Comments on NWMO's Consolidated Information on the Transportation of Used Fuel – Plain Language Summary, IAAC registry reference number 88774

Jaro Franta, 18 March 2026

Consolidated Information on the Transportation of Used Fuel - Plain Language Summary

March 16, 2026 APM-REP-05000-0223 R000

2 Including Transportation in the Impact Assessment

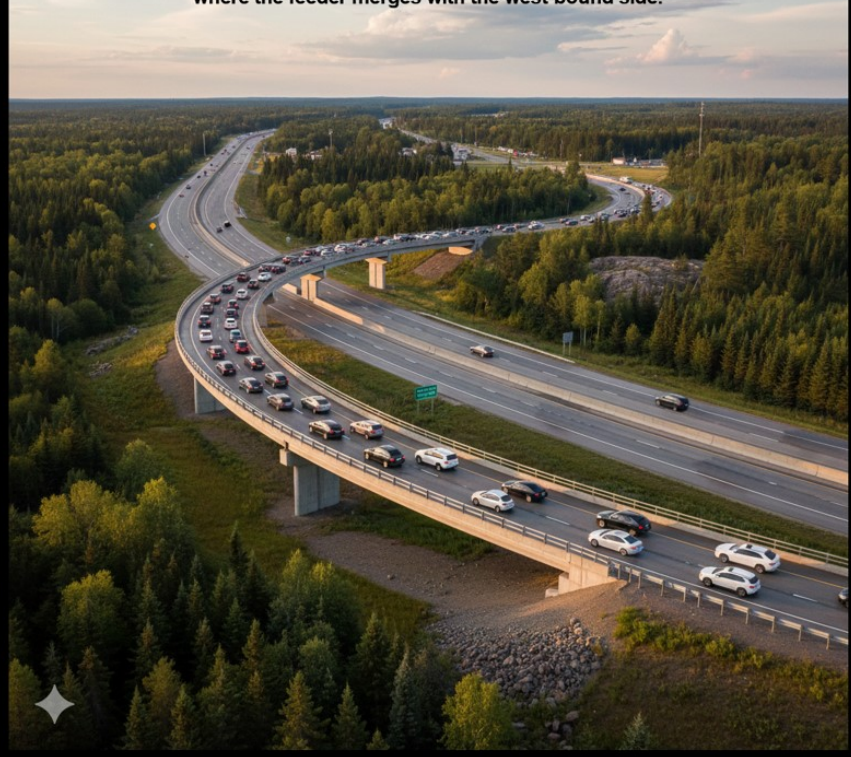
The problem with NWMO's idea of the "construction of a new Hwy 17 turn-off" is that it only takes into consideration the two trucks per day (plus their pilot vehicles) that will be delivering used nuclear fuel to the Revell DGR site.

NWMO is obviously trying to suppress the issue of hundreds of employees commuting daily from Ignace to the Revell DGR site – all of which will be using that "new Hwy 17 turn-off".

For literally hundreds automobiles and trucks, a cheap old "turn-off" on Hwy 17 will be a MAJOR inconvenience (if not a serious traffic hazard), UNLESS that "turn-off" is actually an overpass – at both ends (ie. Revell site AND Ignace town).

“No other changes to highway or railway infrastructure in Canada” (left image) versus railway commuting for NWMO employees and for nuclear waste shipments (right image):

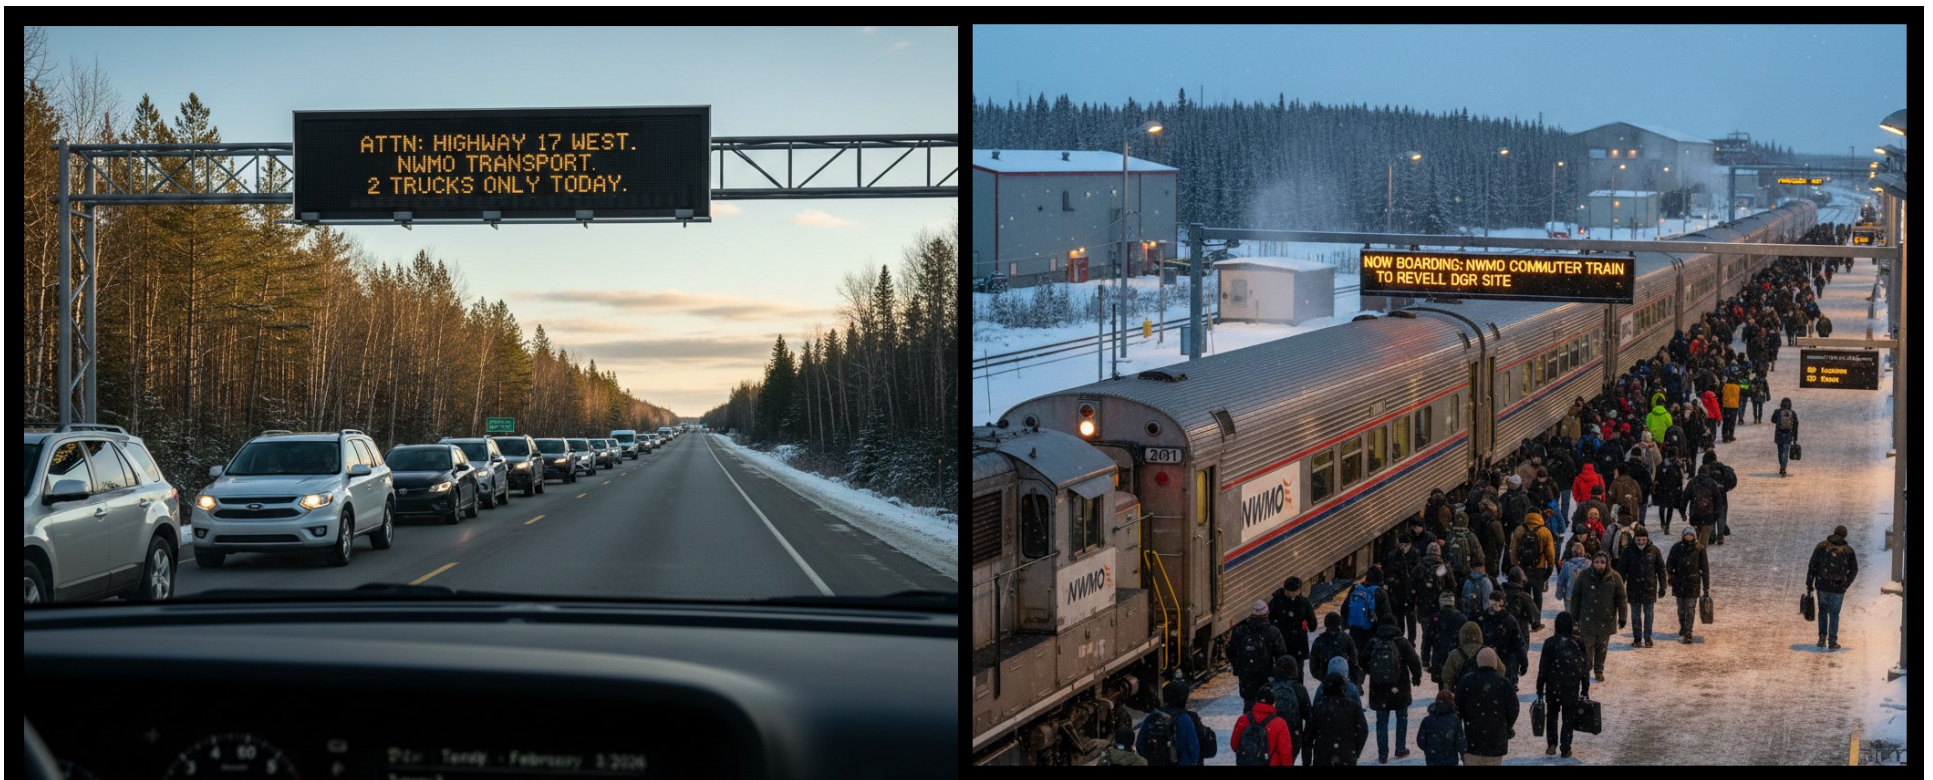
Highway 17 overpass near Ignace to allow NWMO employees on their daily commute to the Revell DGR site, to cross to the north side, where the feeder merges with the west-bound side.

Now, guess what's cheaper: A fancy curving highway overpass (twice!) or a simple railway bridge over Hwy 17, for both nuclear shipments and hundreds of DGR site employees?

This line should be extended a few kilometers north to the CP Rail main line.
